PRODUCT ADVISORY

Data Sheet Specification Correction for Listed Intersil Products

**Refer to:
PA14035**

Subject: **Data Sheet Specification Correction for the listed Intersil Products**

Old POD P3.064 (changes in red) – PA14035

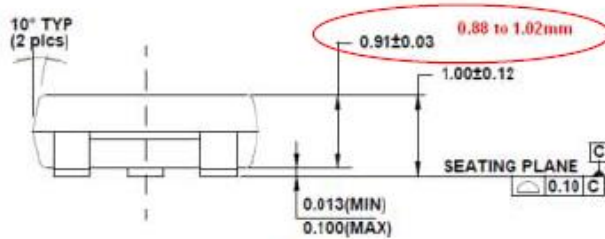
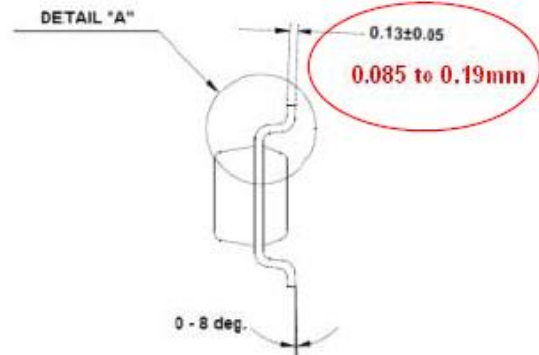
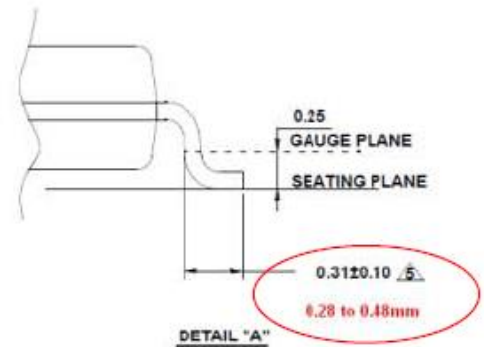
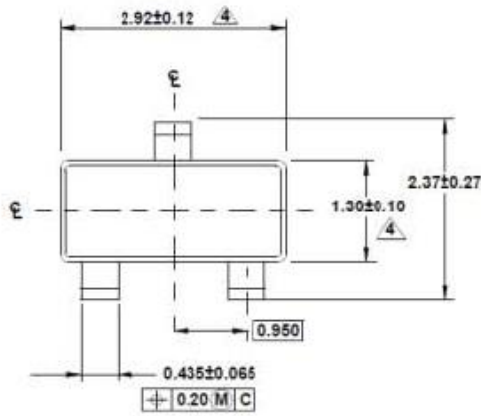
This advisory is to inform you that Intersil has made corrections to the POD (Package Outline Drawing) referenced in the data sheet specification for the listed products. The updates to the POD correct the thickness (height) of the package body. The old POD is marked up below to identify the changes. There have been no changes to the package or product itself. The updated data sheets are available on the Intersil web site for the respective products.
